THE CITY OF SAN DIEGO

MEMORANDUM

SUBJECT: LEIDY RESIDENCE CDP – PROJECT NO. 639782

The subject project's Exhibit "A" has been updated to include the following:

Leidy Residence 6216 Avenida Cresta, La Jolla, CA 92037 GFA EXEMPTION
DIAGRAM

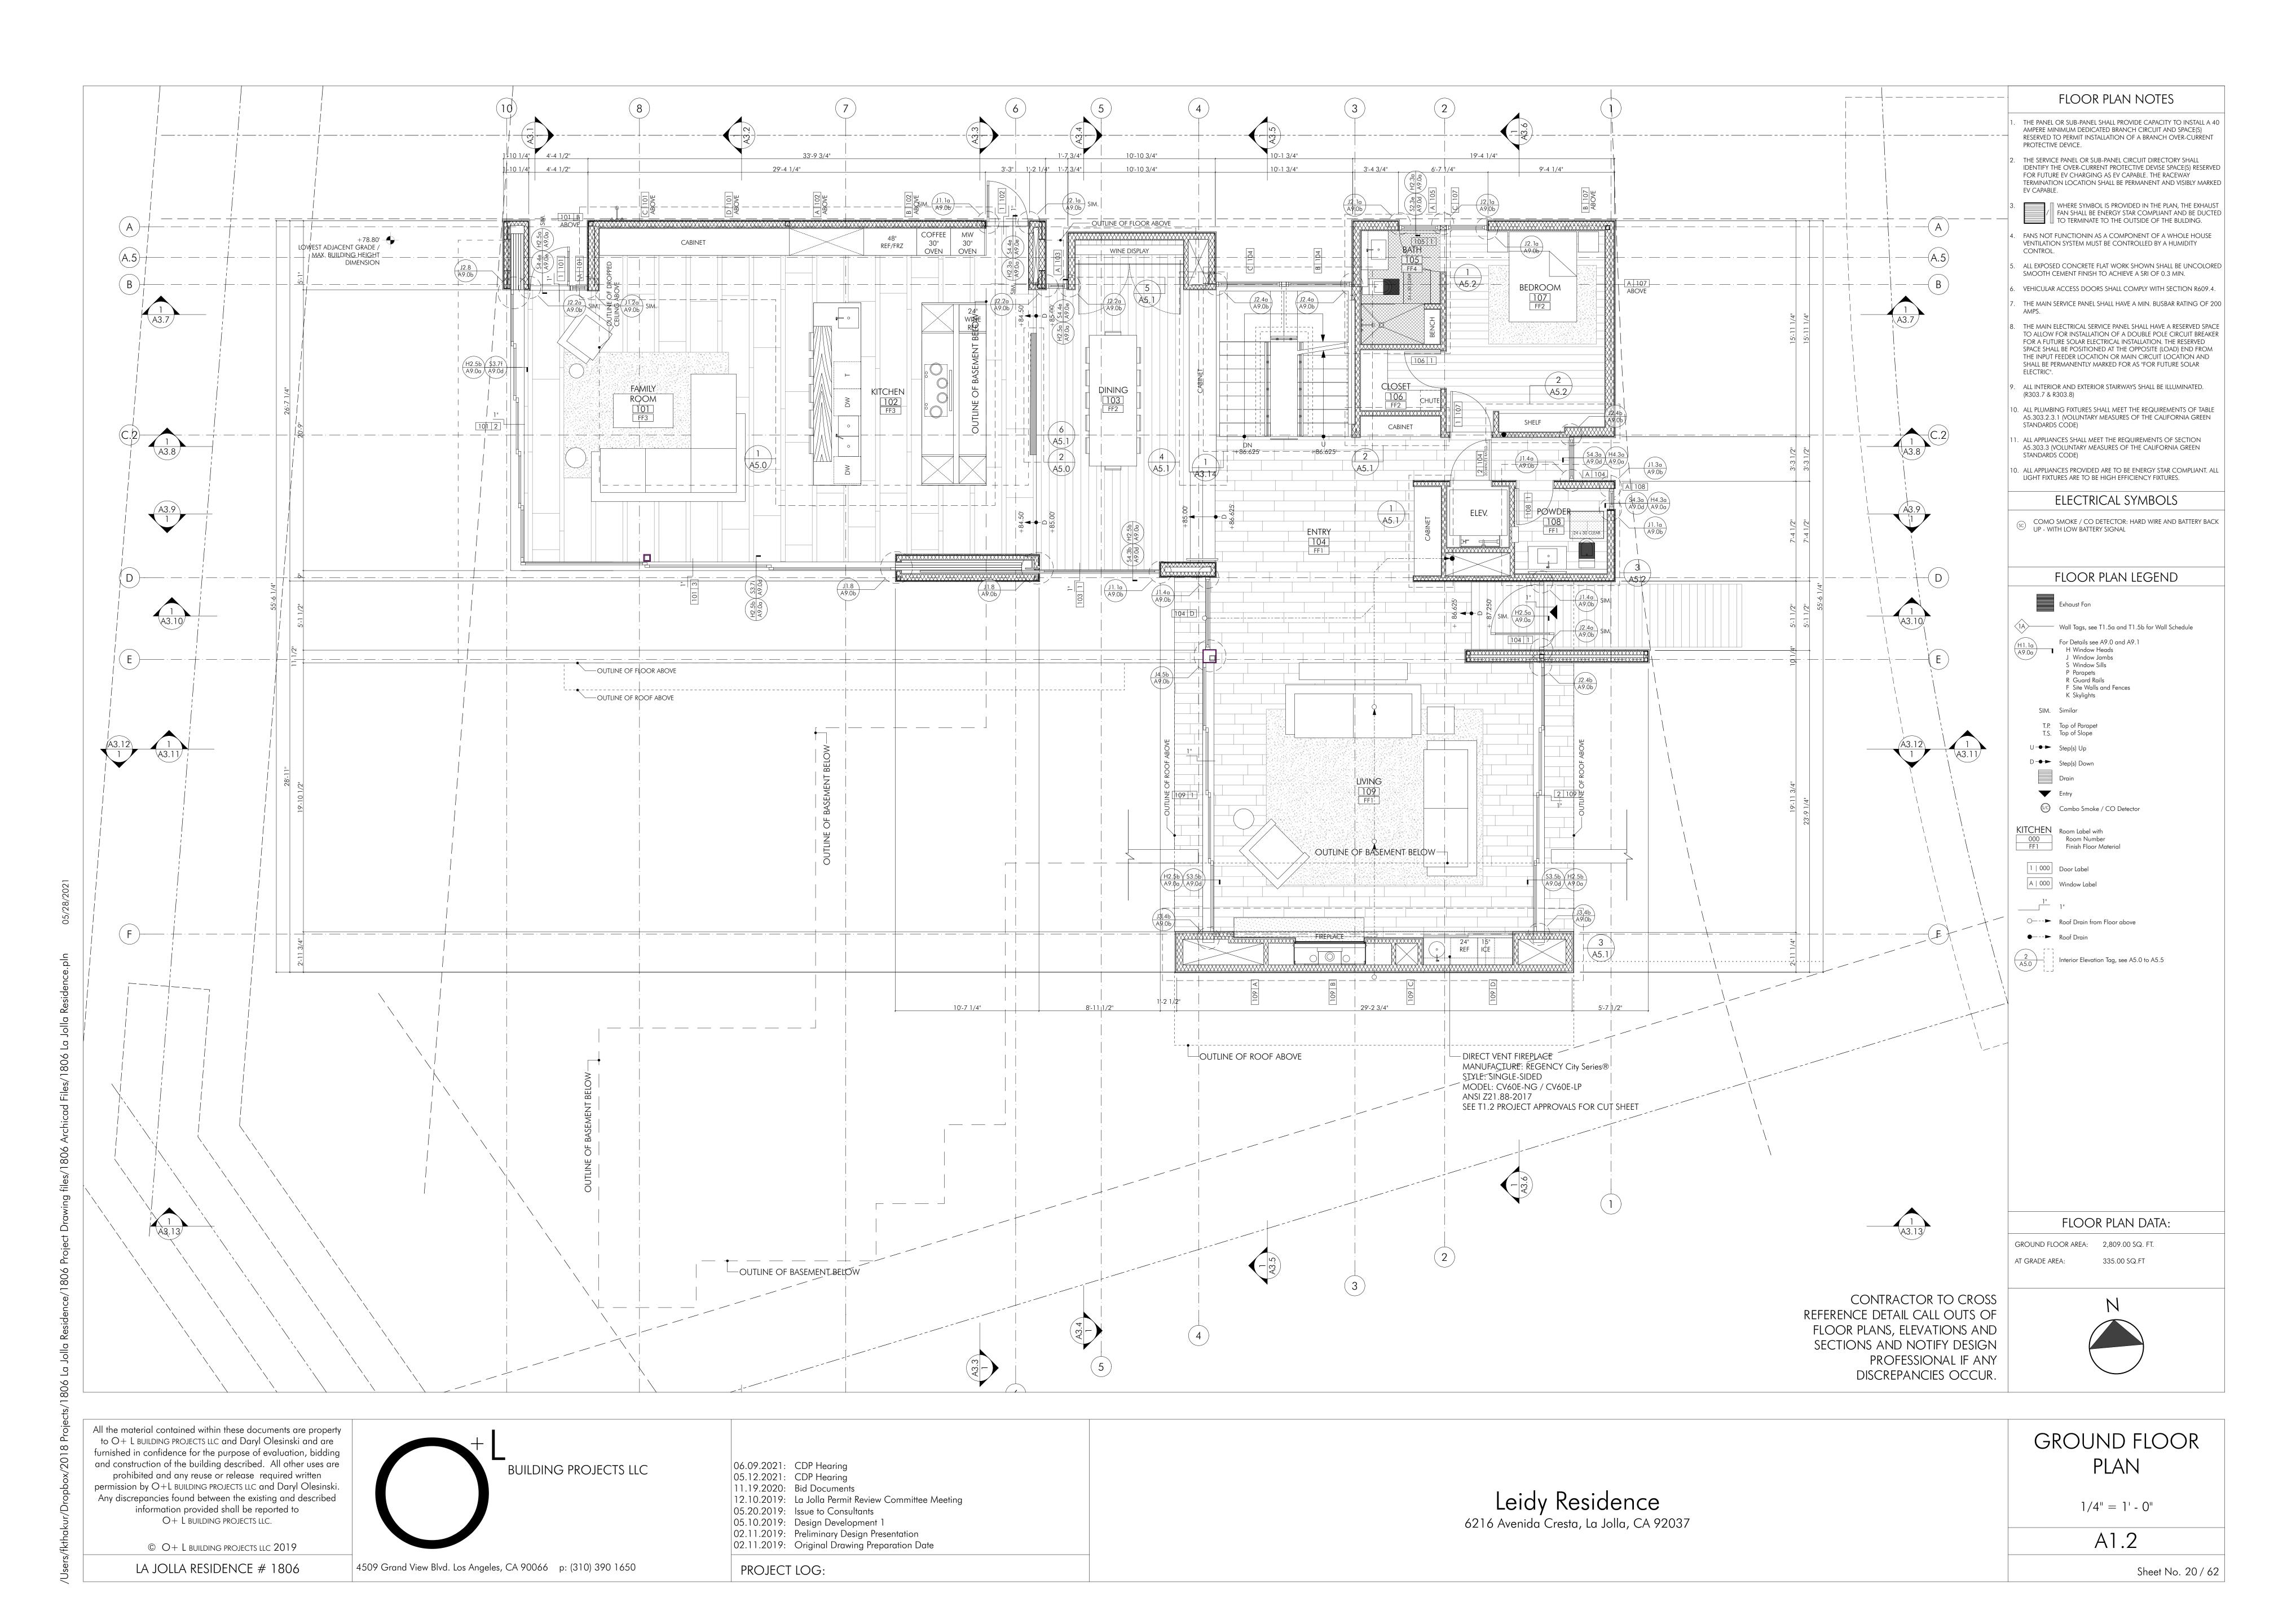
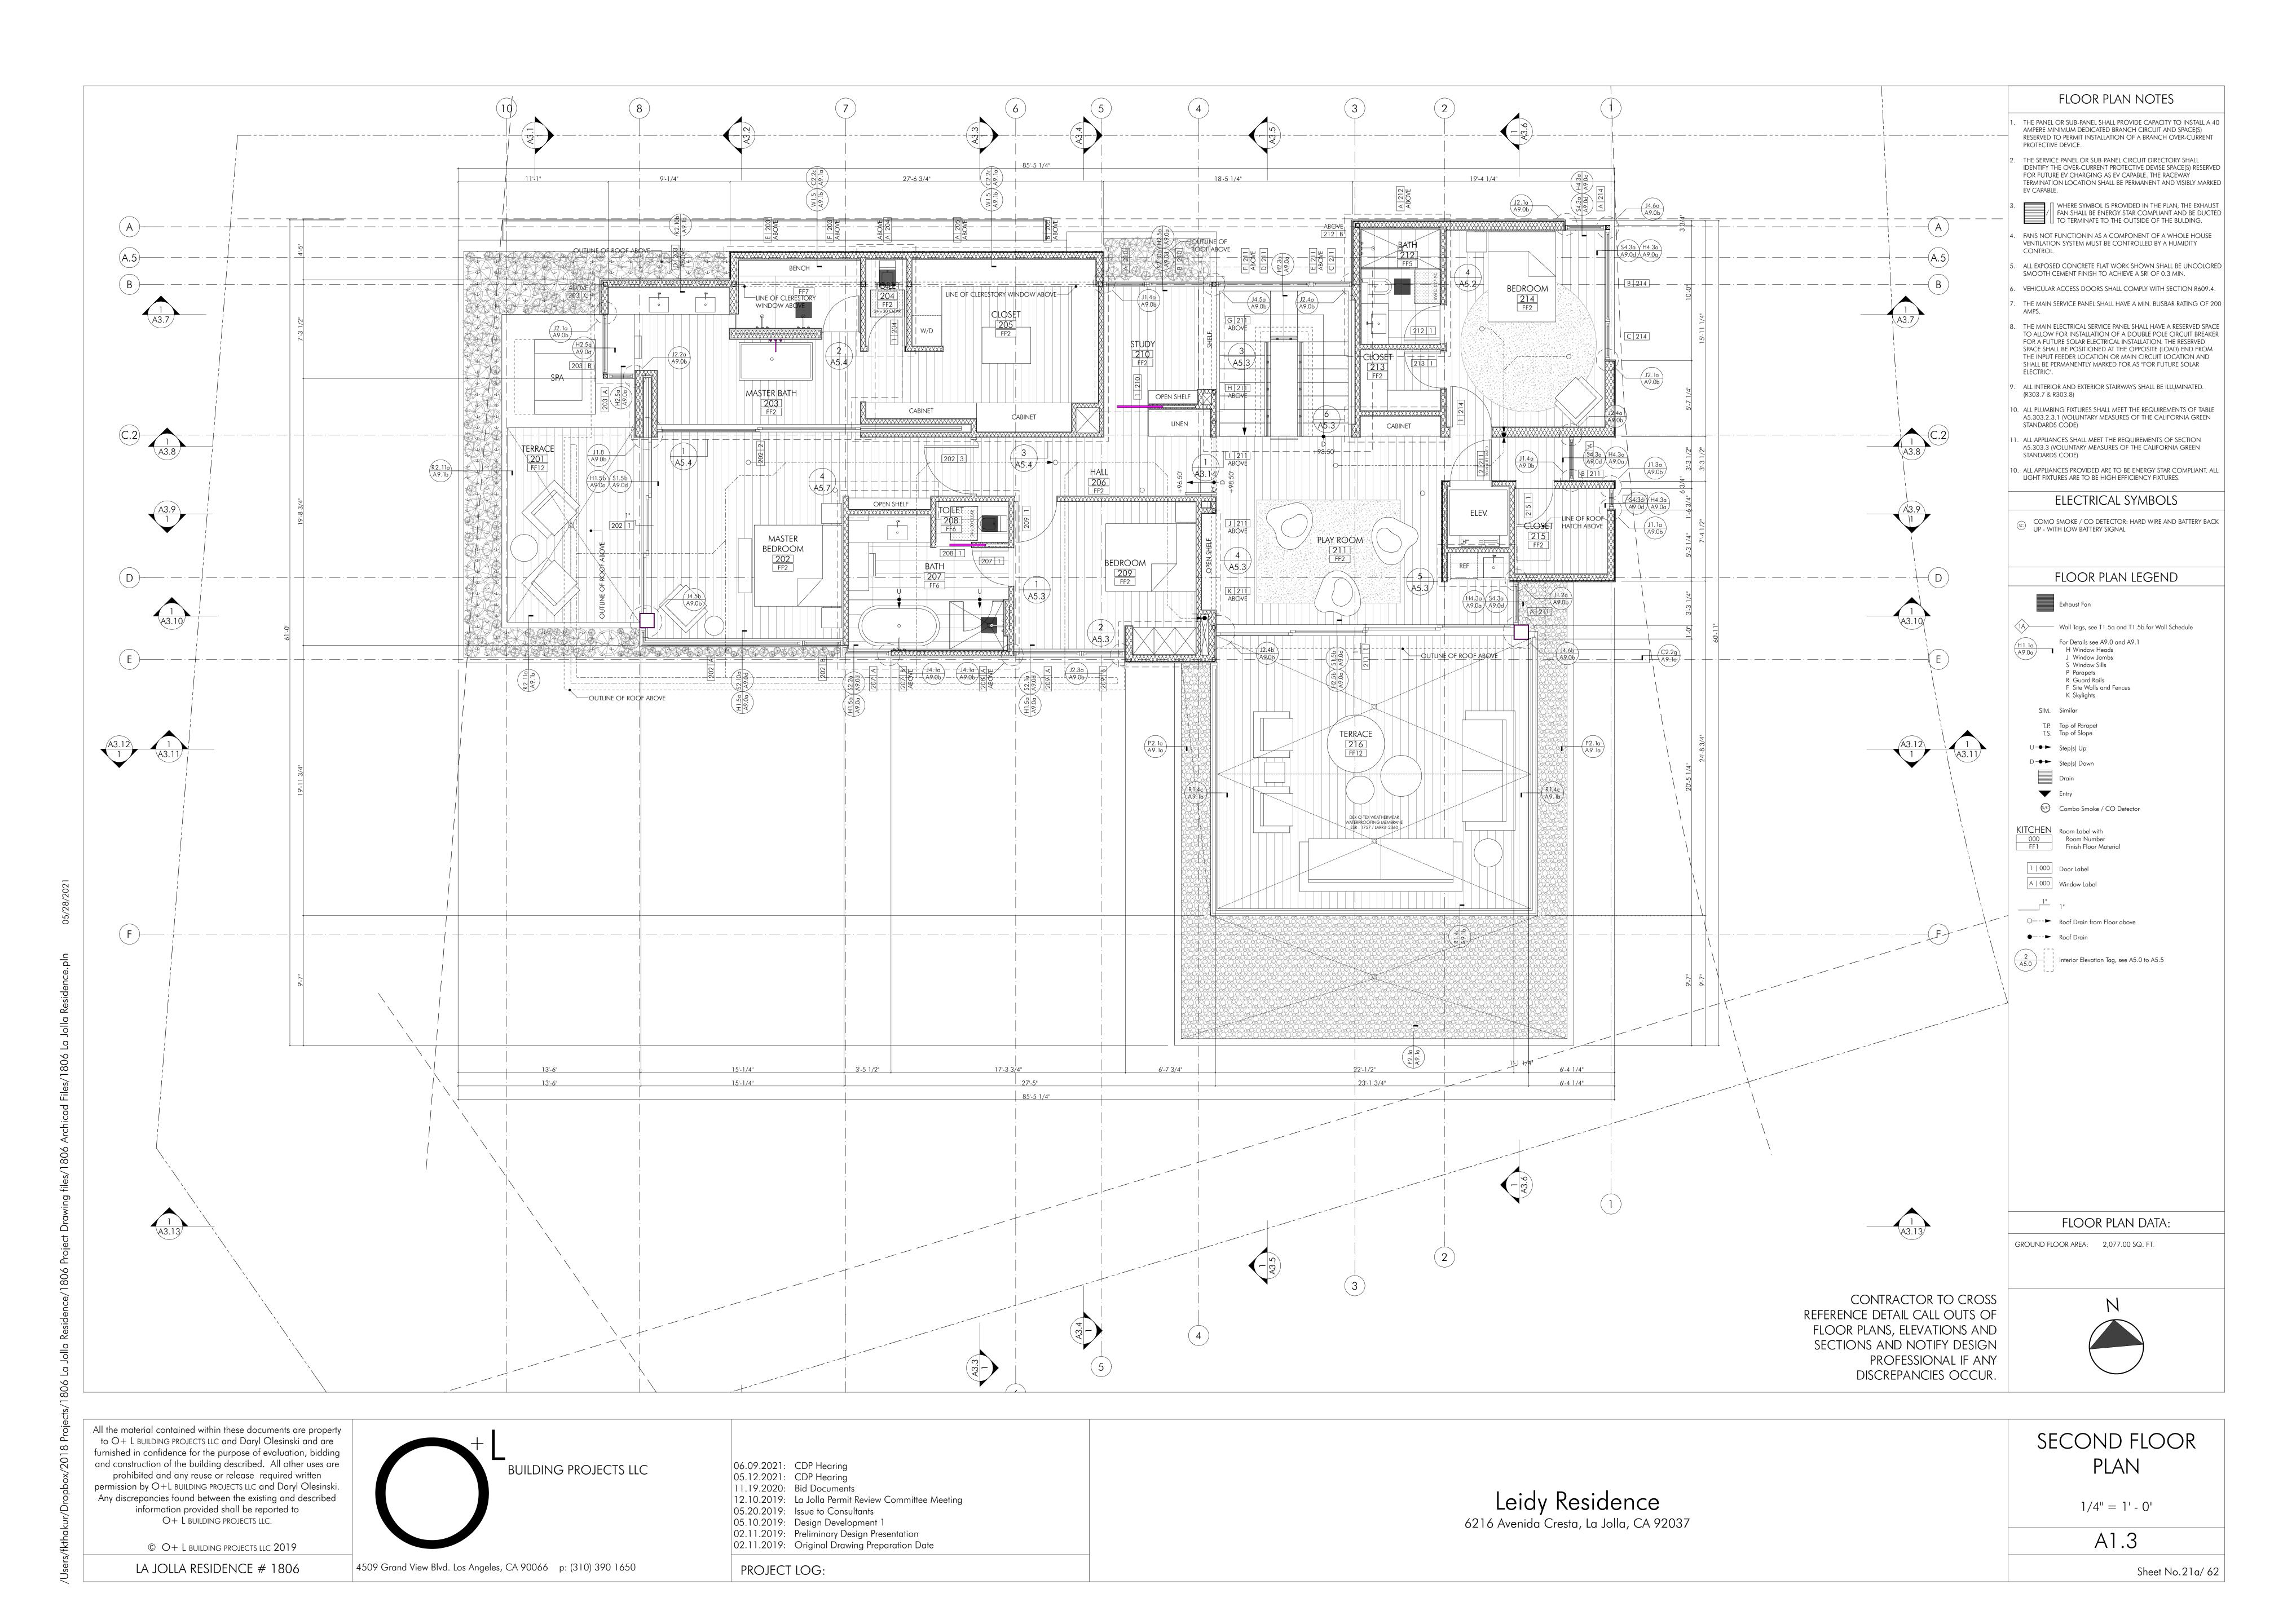
- Renamed the Guest Quarters to an Accessory Dwelling Unit (ADU).
- Revised the Gross Floor Area (GFA) calculation to include the Basement Level ADU and removed the area which was once crawlspace to slab on ground.
 - o Updated Sheet A1.0e to show area not exempt from GFA.
- Reduced height for the retaining wall and added retaining wall labels.
